1 ADDENDUM #2

Client
Parks Canada Agency

Project Title
Entrance & Kiosk Replacement
Brackley Beach, PE

Sheet Title
Concrete Median Detail

1
SK-1 1:20
EQUIPMENT ENCLOSURE - FRONT VIEW

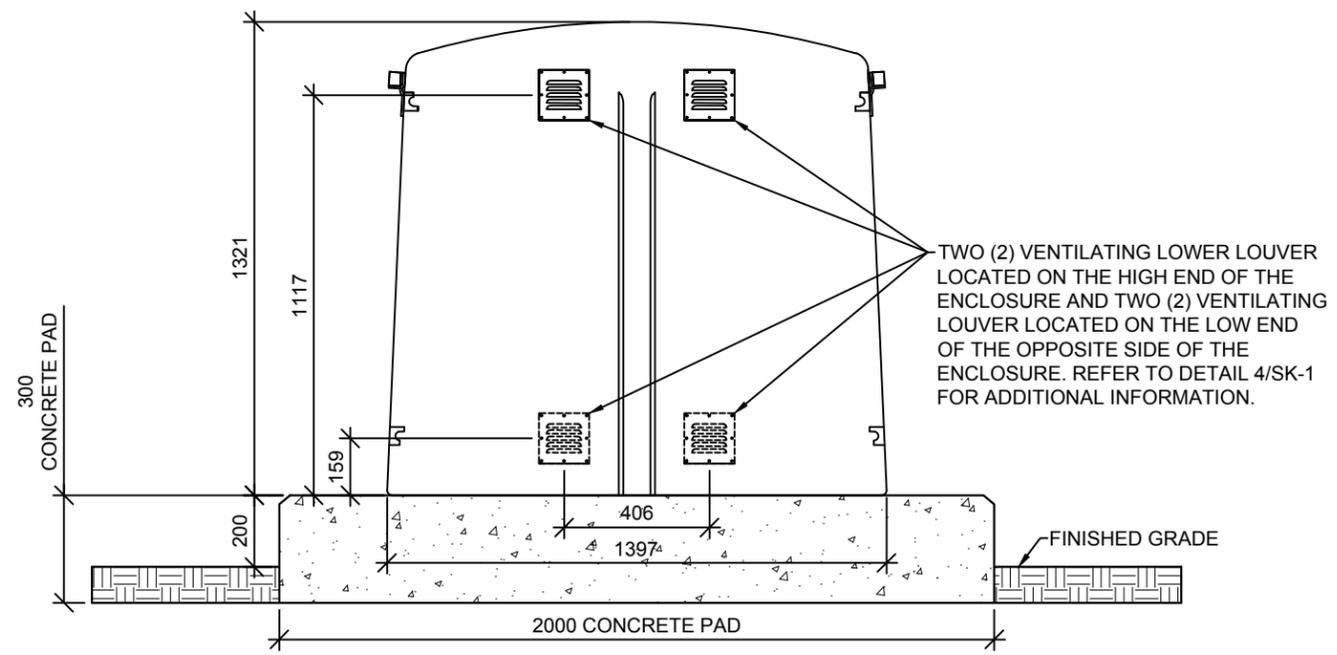
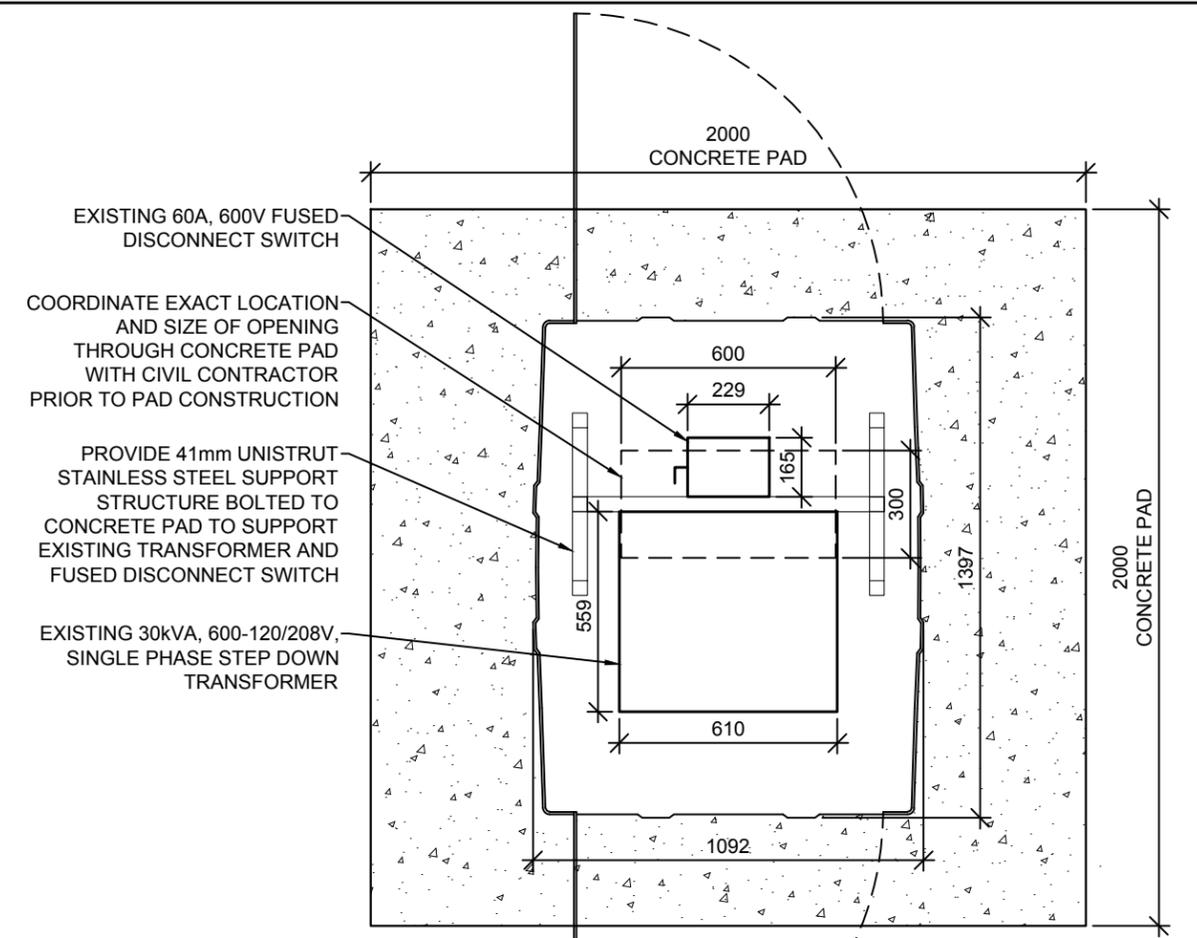
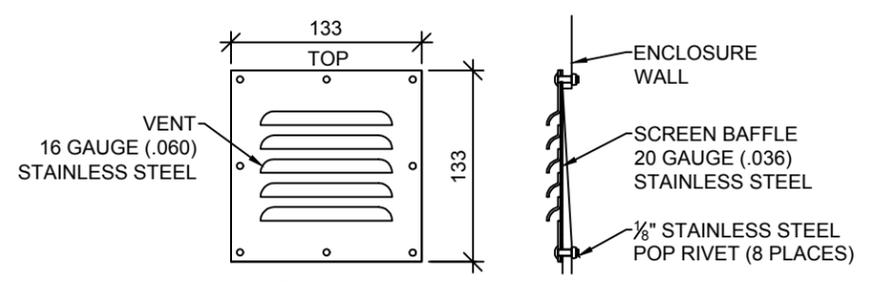
TWO (2) VENTILATING LOWER LOUVER LOCATED ON THE HIGH END OF THE ENCLOSURE AND TWO (2) VENTILATING LOUVER LOCATED ON THE LOW END OF THE OPPOSITE SIDE OF THE ENCLOSURE. REFER TO DETAIL 4/SK-1 FOR ADDITIONAL INFORMATION.

PAD MOUNT EQUIPMENT ENCLOSURE TO BE FIBREGLASS, STAINLESS STEEL HARDWARE, CORROSION PROOF UNIT, UV STABILIZED GELCOAT TO PROTECT ENCLOSURE, LIGHT GREEN FINISH AND C/W TWO (2) VENTILATION LOUVERS LOCATED HIGH ON ONE SIDE AND TWO (2) VENTILATION LOUVERS LOW ON THE OTHER SIDE. ACCEPTABLE MANUFACTURER OR APPROVED EQUAL: POWER DESIGN INC # PE2-43-52-L2-WG

EXISTING 30kVA, 600-120/208V, SINGLE PHASE STEP DOWN TRANSFORMER. EXISTING TRANSFORMER TO BE SECURELY FASTENED TO UNISTRUT SUPPORT STRUCTURE

EXISTING 60A, 600V FUSED DISCONNECT SWITCH. SECURELY FASTEN TECK CABLES WIRED FROM FUSED DISCONNECT SWITCH TO PRIMARY SIDE OF EXISTING TRANSFORMER TO UNISTRUT SUPPORT STRUCTURE. FUSED DISCONNECT SWITCH TO BE SECURELY FASTENED TO UNISTRUT SUPPORT STRUCTURE

1 SECTION VIEW
SK-2 1:10

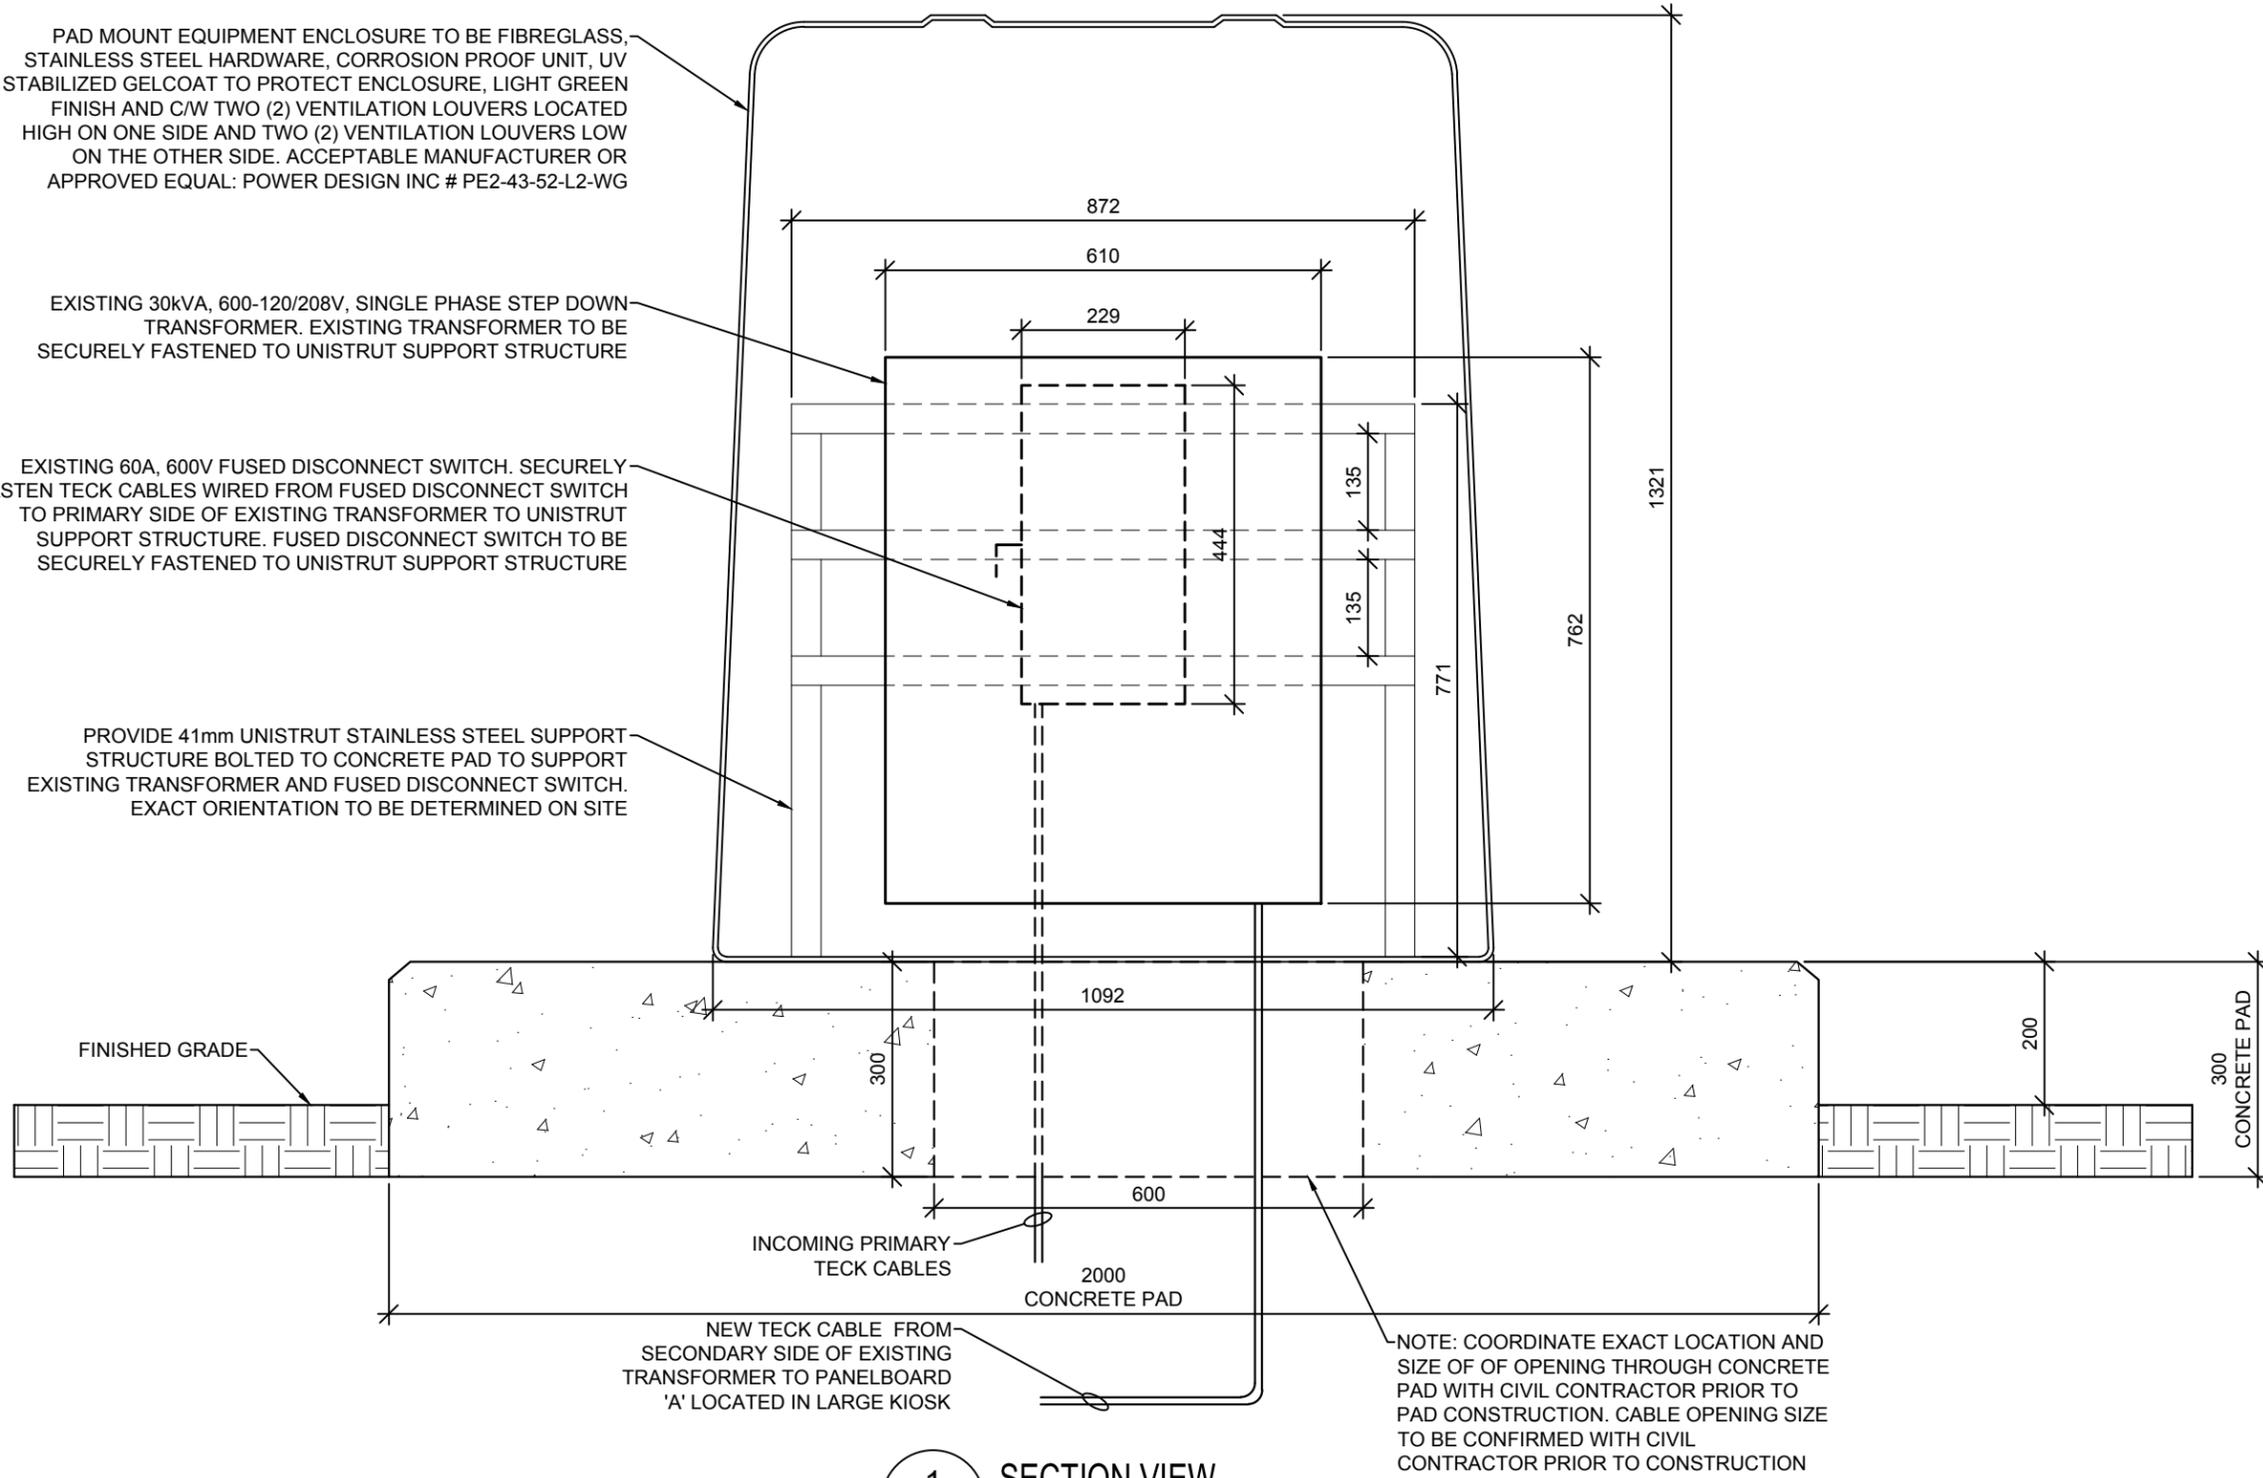
PROVIDE 41mm UNISTRUT STAINLESS STEEL SUPPORT STRUCTURE BOLTED TO CONCRETE PAD TO SUPPORT EXISTING TRANSFORMER AND FUSED DISCONNECT SWITCH. EXACT ORIENTATION TO BE DETERMINED ON SITE

1 SECTION: CURB / CONCRETE MEDIAN
SK SK 1:20

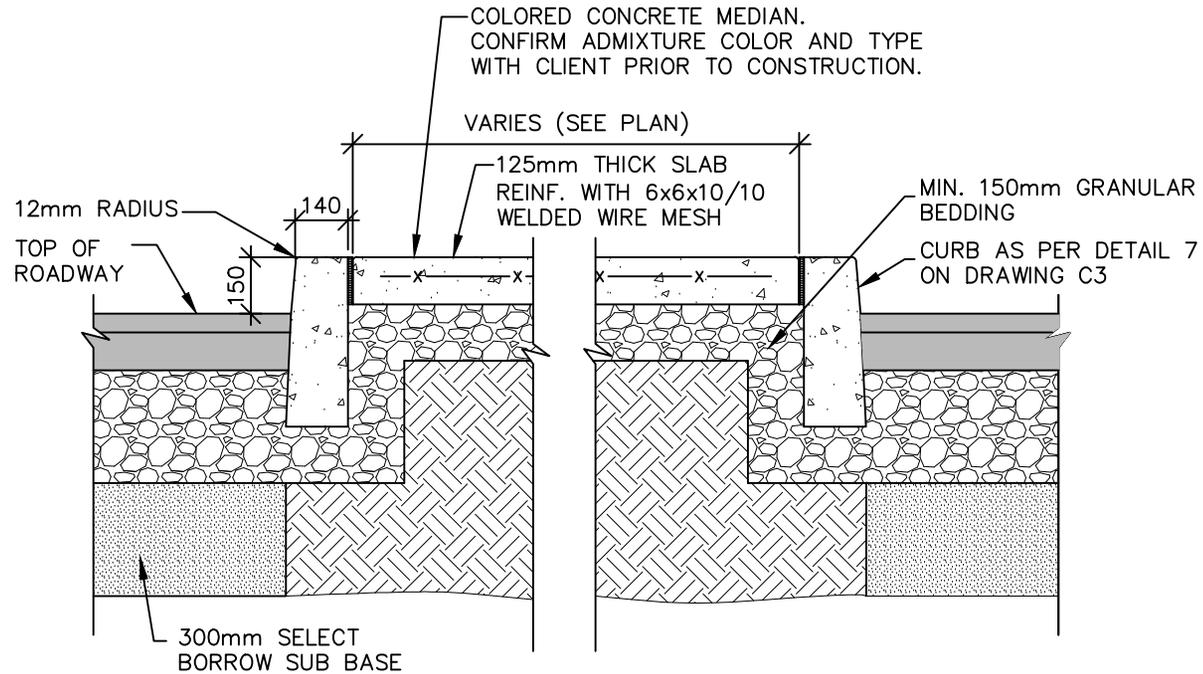
- .1 Add New Site Note:
 - .1 Add new Site Note 17 as follows:
"Provide new cast in place colored concrete median as detailed in attached sketch, SK-03 Concrete Median, issued with and forming part of this addenda."
